**General Bid Bulletin No. 12**

29 November 2021

**METRO MANILA SUBWAY PROJECT PHASE I**

**PACKAGE CP103:  
TWO UNDERGROUND STATIONS (ANONAS AND KATIPUNAN)  
AND TUNNELS  
(IFB No: 21-035-6)**

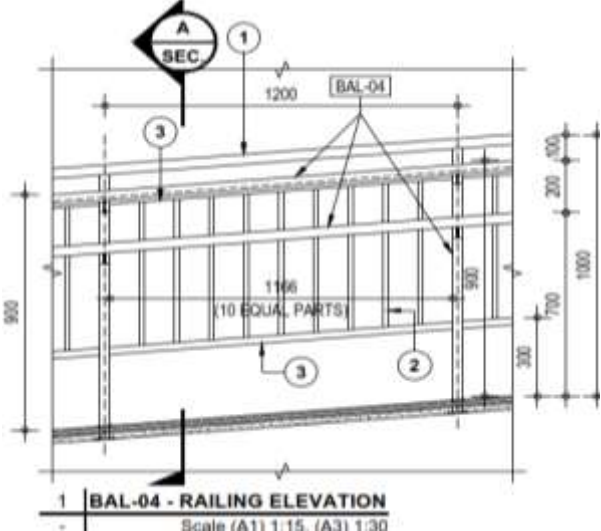
5.	<p>Bill of Quantities Aluminum Bandless Gutter</p>	<p>At Bill of quantities, Pay item 1017(1)b Aluminum Bandless Gutter (4set) is indicated</p>	<p>Refer to drawing on Entrance, section for detail as shown below(STN-AR-A-KP-9112), Roof Level Plan</p>

<p>at Bill No.4B. Please provide construction range for this item because we cannot find this in the drawings.</p>	<p>and Entrance Terrace Level Plan for the extent.</p> <p>STN-AR-A-EA/QA/KP/AN-6000 to 7000 po for entrance elevations.</p>  <p>STN-AR-A-EA/QA/KP/AN-9112 for the typical details.</p>
--	--	--	--

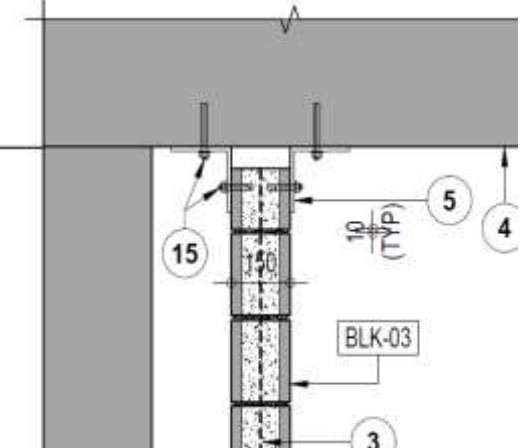
58.	Vol. II , Sec.VI General Specification,	We wish to obtain clarification on the MEP	(Refer to GS 119.3.2 Working Drawing -- Contractor

<b>Metro Manila Subway Project Phase 1 PACKAGE CP103 (Anonas and Katipunan)</b>			
<b>ITEM NO.</b>	<b>REFERENCE/CLAUSE/SECTION</b>	<b>QUERIES</b>	<b>RESPONSE</b>
	Technical Specification MEP Design Scope	design scope. Appendix 1 (Scope of Works) of the General Specifications, section 2.2.(3) (E&M Works), item (a) defines the scope as the 'design and manufacture, installation and commissioning of the E&M station and tunnel works'. However, we understand the project is essentially a 'construction-only' contract, and that any design scope is limited to where specifically defined in the more detailed technical specifications. We note also that in the same Appendix 1, for the Underground Stations and Tunnel structures, no reference is made to 'design'. Referring to Volume II, PART 2 of the Works Requirements, Section VI Technical Specifications (TS) 3: Mechanical, Electrical and Plumbing, the General Requirements make no clear reference to any detailed Employers Requirements or Design Criteria from which the Contractor would otherwise need to carry out any design, and for items such as the Tunnel Ventilation System and Smoke Control System, it also refers to them as already having been designed (by the Employer's consultants).	shall follow GS115) GS Appendix 1 Scope of Work "design and manufacture, installation and commissioning of the E&M station and tunnel works'. .." to be amended as "Supply, Installation, commission of E&M Station and Tunnel.." Please see Annex B The Working drawing to be provided by Contractor as specified in TS, Section 6 Work Requirement Article 3

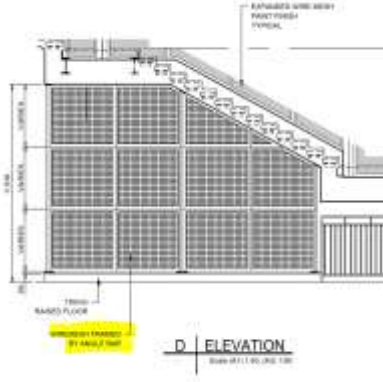
82.	Vol. II , Sec.VI Technical Specification; Part 1226.1.2	Please confirm that the SES ( Subway Environmental Simulation) shall only be	SES is already conducted as per current Tunnel and Station geomterty

<b>Metro Manila Subway Project Phase 1 PACKAGE CP103 (Anonas and Katipunan)</b>			
<b>ITEM NO.</b>	<b>REFERENCE/CLAUSE/SECTION</b>	<b>QUERIES</b>	<b>RESPONSE</b>
	SES Tunnel Ventilation System	undertaken and provided during post contract period.

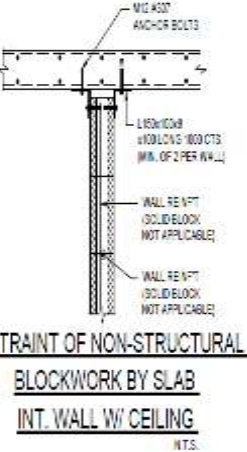
96.	Drawing STN-AR-A-AN-9412, 9413 STN-AR-A-KP-9412, 9413 Crane Hoist Assembly	According to drawings, there are 5 double crane rails and 1 single crane rail in each station. Please confirm.  Please provide also the maximum capacity of moving hoist beam with hook assembly. At Grid 18-19 and grid 30-31, it was clearly noted that maximum capacity is 25ton, but single rail at	Yes, 5 double crane rails (TTS - 2nos, Generator - 1 no, Access hatch -2 nos) and single rail (SSS - 1 no) are provided in each station. Moving hoist beam is only at TSS & Generator room and its maximum capacity is provided in dwg 9412, 9413 (TSS at grid 30-32 is 25 ton capacity Generator room at grid 18-19 is 25 ton capacity) Lifting hook details are provided in Detail A, 9412.

<b>Metro Manila Subway Project Phase 1 PACKAGE CP103 (Anonas and Katipunan)</b>			
<b>ITEM NO.</b>	<b>REFERENCE/CLAUSE/SECTION</b>	<b>QUERIES</b>	<b>RESPONSE</b>
		grid 25-26 and double rail at grid 4 and grid 35-36, no details were shown.

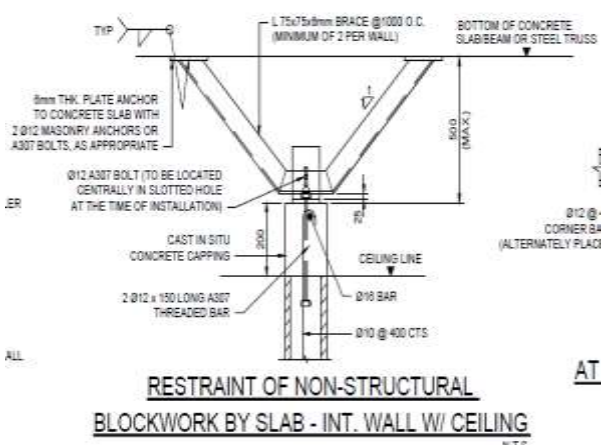
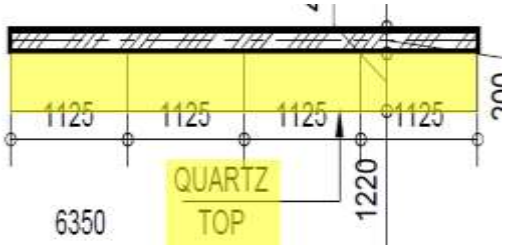
99.	<p>STN-AR-A-AN-7007 STN-AR-A-KP-7008 STN-AR-A-AN-9300 STN-AR-A-KP-9300 GL-05 Thickness and Specification Glass Door</p>	<p>There appears to be a conflict in the glass thickness and its specification in the drawings.</p> <p>In the Door Schedule shown in drawing STN-AR-A-AN-7007, Door type T7 mentions "Glass: Tempered Fire Glass Panel t=16mm Fire Glass Panel with Security Film.</p> <p>However, in drawing STN-AR-A-AN-9300, GL-05 for the glass doors is mentioned as 12mm thk. toughened glass with design film.</p>	<p>Door Schedule drawings has been updated in July submissdion as 16mm the same as GL-05. .</p>

<b>Metro Manila Subway Project Phase 1 PACKAGE CP103 (Anonas and Katipunan)</b>			
<b>ITEM NO.</b>	<b>REFERENCE/CLAUSE/SECTION</b>	<b>QUERIES</b>	<b>RESPONSE</b>
		Please advise which thickness and specification shall be followed for both stations.

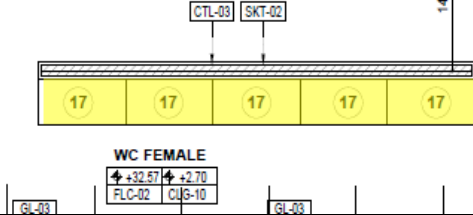
101.	STN-AR-A-AN-9001 STN-AR-A-KP-9001 STA-S-AN-3010 STA-S-KP-3010 Top attachment angle	1. There is a conflict in the angle size for the termination of the blockwork.  a) Architectural drawing - L 150 x 150 x 8 b) Structural drawing - L 150 x 100 x 8 x 100mm long  Please advise which size to follow.  2. Based on the structure drawing, the bidder understands that these angles are not continuous. Therefore, please confirm that the spacing of angle bar is 1000mm O.C.	1. Architecture drawings shall be corrected to indicate dimensions as per structure drawings. 2. As indicated in the detail, it is confirmed that the interval of angle bar is at every 1000mm O.C. 3. For general partition wall purposes, the intumescent painting is required on the angle bar.

ITEM NO.	REFERENCE/CLAUSE/SECTION	QUERIES	RESPONSE
		<p style="text-align: center;">N.T.S.</p>  <p style="text-align: center;">3. The solid blocks 150mm and 175mm need to be 2hr and 3hr fire rated respectively. Do we need to apply intumescent paint for angle bars on fire rating blockwalls?</p>	
102.	STA-S-AN-3010 STA-S-KP-3010 Restraint of Non-Structural Blockworks	Please advise the room/areas require this type of detail.	The detail is used in janitor room wall at platform level which has a low height gypsum wall

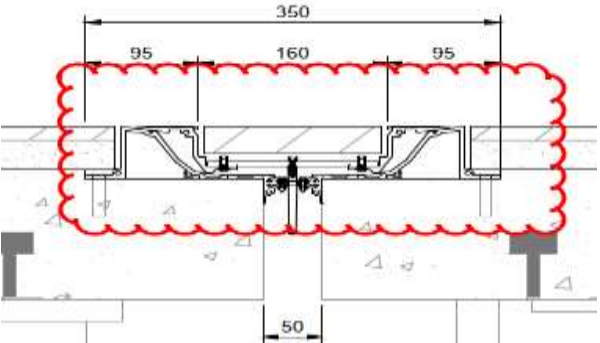
105.	STN-AR-A-KP-7007 STN-AR-A-AN-7007 Lock type -BMS	<p>Please confirm the meaning of Lock-type-BMS. TS Specification 1818 does not mentioned about BMS. Please clarify the type of lock, and the</p>	<p>Type of lock is electlic magnetic lock or equivalent type controlled by BMS.</p> <p>TS shall be updated.</p>

<b>Metro Manila Subway Project Phase 1 PACKAGE CP103 (Anonas and Katipunan)</b>			
<b>ITEM NO.</b>	<b>REFERENCE/CLAUSE/SECTION</b>	<b>QUERIES</b>	<b>RESPONSE</b>
	Door No. KP-B1F/D-18 and Door No. AN-B1F/D-36	Acronym BMS Stands for.	BMS is Building Maintenance System under the scope of MEP.

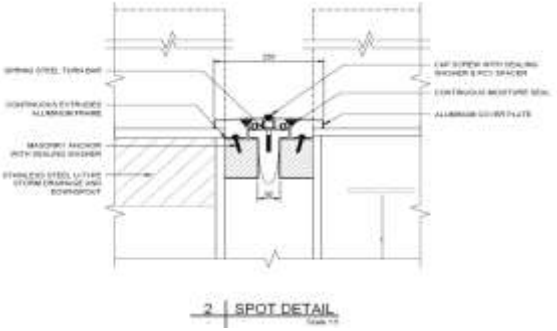
111.	20 / Ped_AN /SPL-PB1-A-AN-2014, 21 / Ped_KP /SPL-PB1-A-KP-2014 Tempered Safety Glass	At SPL-PB1-A-AN-2014 ANONAS STATION PEDESTRIAN BRIDGE 1 ELEVATOR TYPICAL DETAILS and SPL-PB1-A-KP-2014 KATIPUNAN AVENUE STATION PEDESTRIAN BRIDGE 2 ELEVATOR TYPICAL DETAILS, may we assume that Tempered Safety Glass to be included at MECHANICAL WORKS - ELEVATORS under Elevator finishes?	Tempered Safety Glass is included in Elevator Finishes.
